# MEMORANDUM

| <b>Service</b>              | WBC Ecology                                                                                                                                                                                                                                                                                                                                                                                                                                                                  | <b>App No:</b> | 252252 |
| <b>Address:</b>             | L'Ortolan Restaurant, Church Lane, Shinfield, Wokingham, RG2 9BY.                                                                                                                                                                                                                                                                                                                                                                                                            |                |        |
| <b>Proposal:</b>            | Listed Building Consent for the proposed erection of a rooftop extension with terrace decking to the existing ma

Photographic plate showing T13 (centre). (ROAVR, 2025)

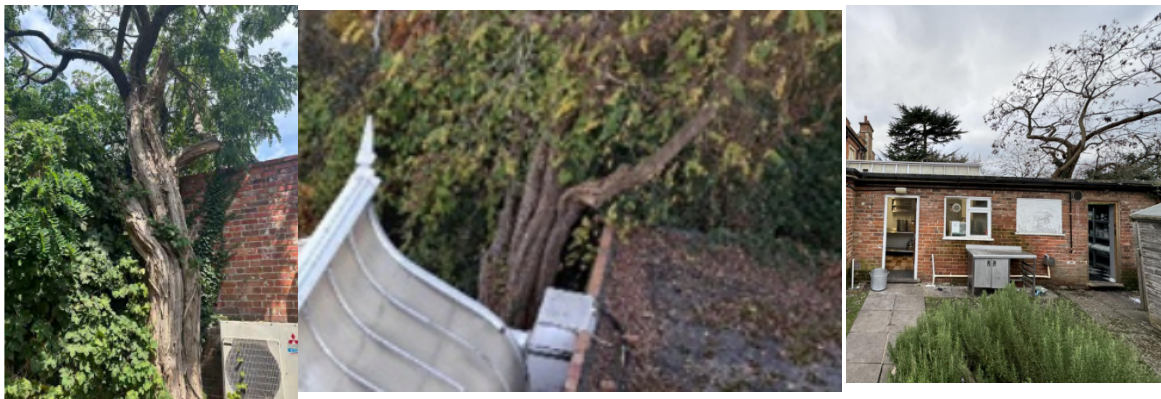
T11 is described by the Arboricultural Consultant as having a cavity and shear bomb cracks. T11 is not included in the Tree Removals table. T11 is categorized as B1, and its loss is not justified. According to the AIA, it can be protected and retained in the long-term.

It is not clear if the Ecologist assessed the impact of the removal of T13 and whether this tree may also include features suitable for bats as no habitat plan is included in the PRA report. They fail to report that mature ivy on the tree has been severed. The Ecologist has not taken account that this tree is just 30m from the maternity bat tree roost to northwest recorded at The Manor. The AIA describes Hawthorn T13 described as having Ivy, a stem that divides below 1.5m. The Arboriculturist recommended no works to the tree and the reason for proposed removal therefore appears to be to facilitate redevelopment of the Annex which has now been removed from the current phase of development proposals.
